AERONAUTICAL CHARTING FORUM
Instrument Procedures Group
Meeting 09-01 - April 29-30, 2009

RECOMMENDATION DOCUMENT

FAA Control # 09-01-213

Subject: Guidance & Charting for TERPS Chg 21 Circling Approaches

Current procedure profile view:

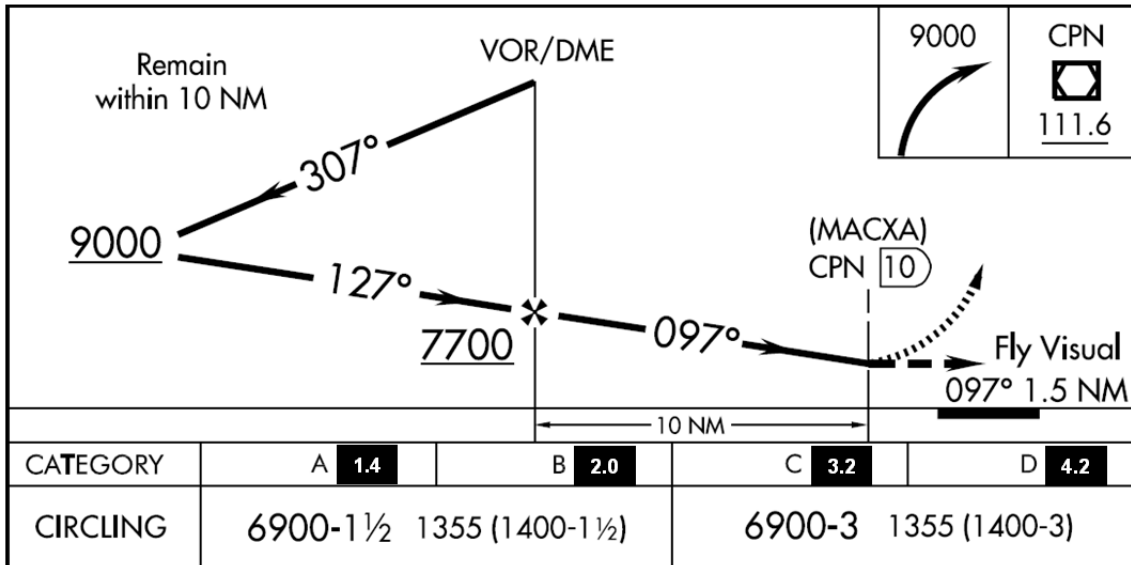
One possible option is to add an ICON that identifies the extent of the circling protected airspace afforded at the CMDA. This ICON would be placed in the profile view, next to the Approach Category letter and would indicate the CAR radius used to define the protected airspace. An example of the use of this ICON is illustrated on the examples below for the Butte/Bert Mooney Airport, Butte MT VOR or GPS-B approach:

The icon next to each approach category depicts the TERPS 21 CAR that defined the protected circling airspace. This provides the pilot with the information necessary pre-plan the circling maneuver so as to remain within protected airspace and locate a descent point that best results in a normal, stabilized approach. The type and nature of the ICON is left to the discretion of NACO and the commercial charting agencies.

Fig 1

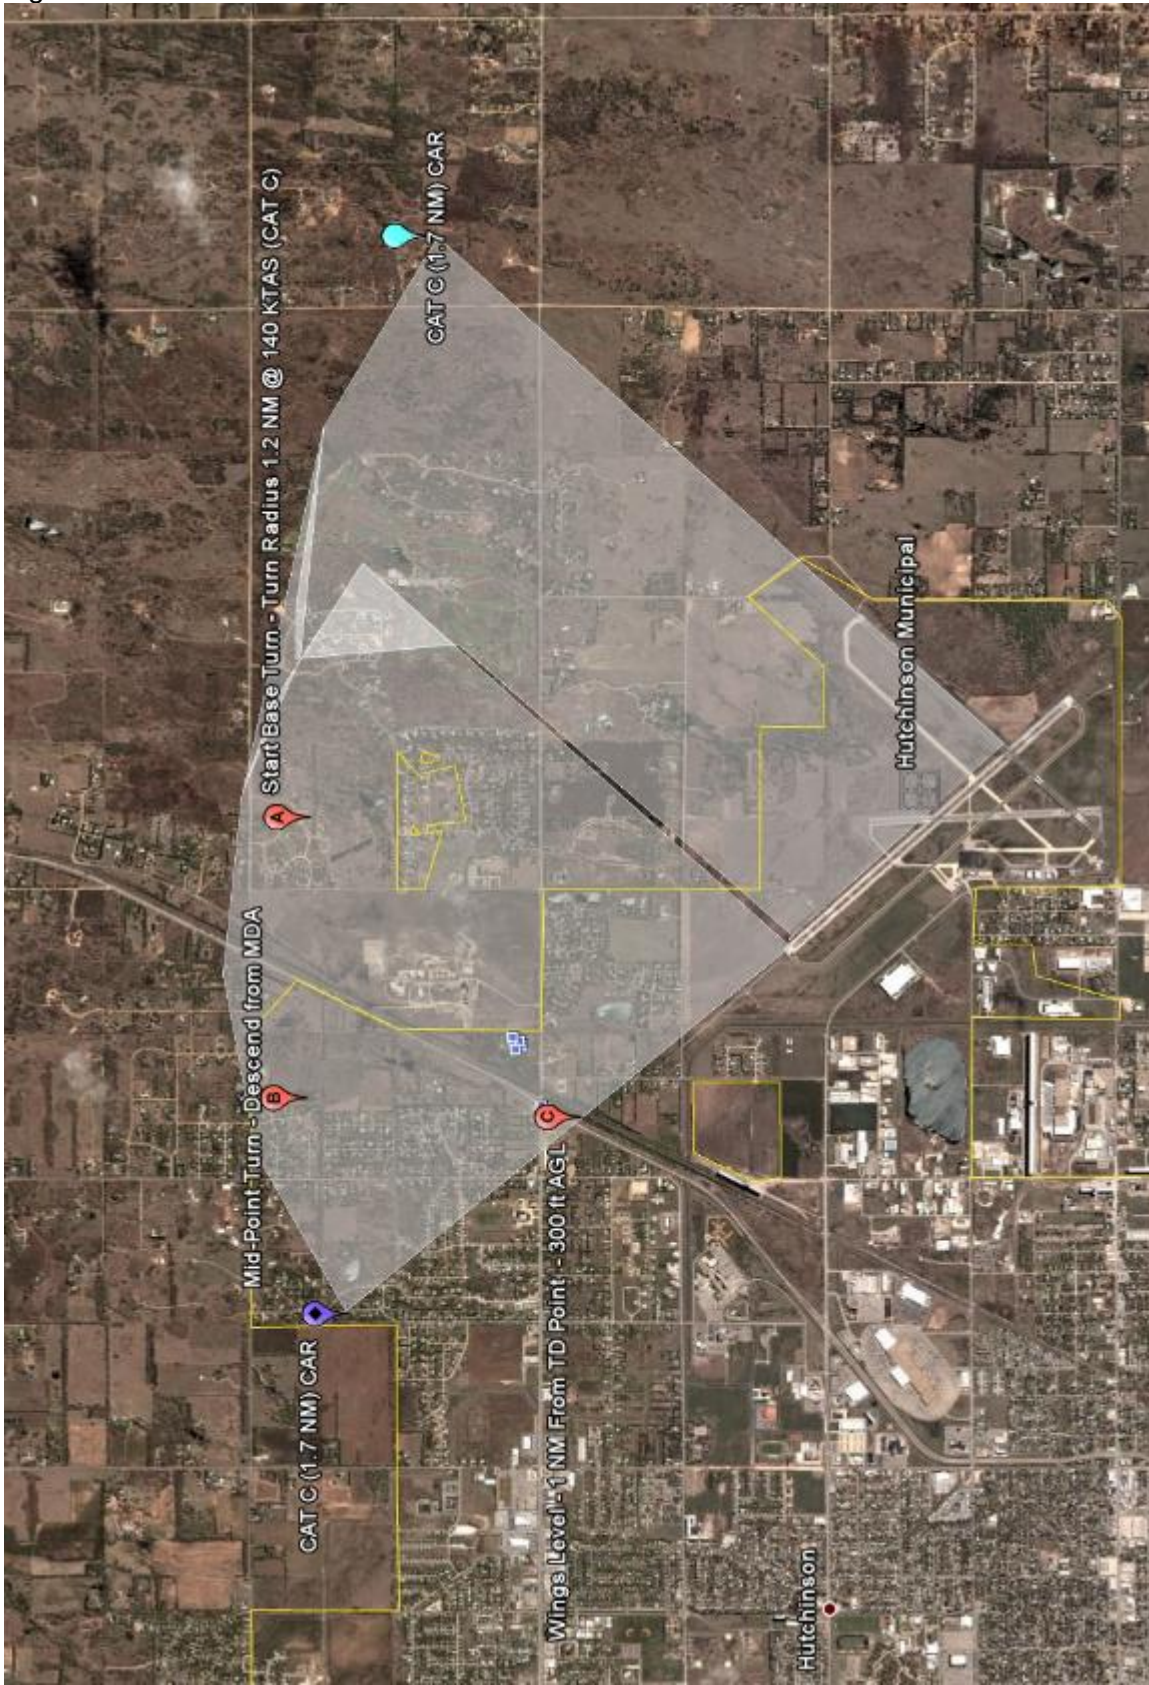
Fig 1 illustrates a nominal circle-to-land approach from a typical CAT C HAA of about 600 ft. In order to arrive at "in-slot" position on the landing runway, the turn radius resulting from the 140 KIAS CAT C speed limit takes the aircraft nearly to the edge of, but still within the CAT C circling protected airspace. The descent from MDA may begin approximately midway through the turn from base to final so as to arrive at the "in slot" position at the correct height. Even with an HAA approaching 1,200 ft, a descent beginning abeam the touchdown point will allow a normal stabilized descent to arrive at "in-slot" position at the correct height above the runway.

However, when the HAA exceeds 1,200 ft, the ability to conduct a stabilized approach becomes problematic for the pilot. When the HAA exceeds 1,200 ft, the descent must be commenced earlier in the circling maneuver, which is often impractical based on the aircraft's position relative to the landing runway. The only other option remaining to the pilot is to use a higher than normal descent rates to complete the descent. To remain within the pre-TERPS 21 CAT C circling protected airspace when the HAA exceeds 1500 ft, a descent gradient in excess of 400'/NM (1000 FPM) is necessary when descending from the abeam touchdown position
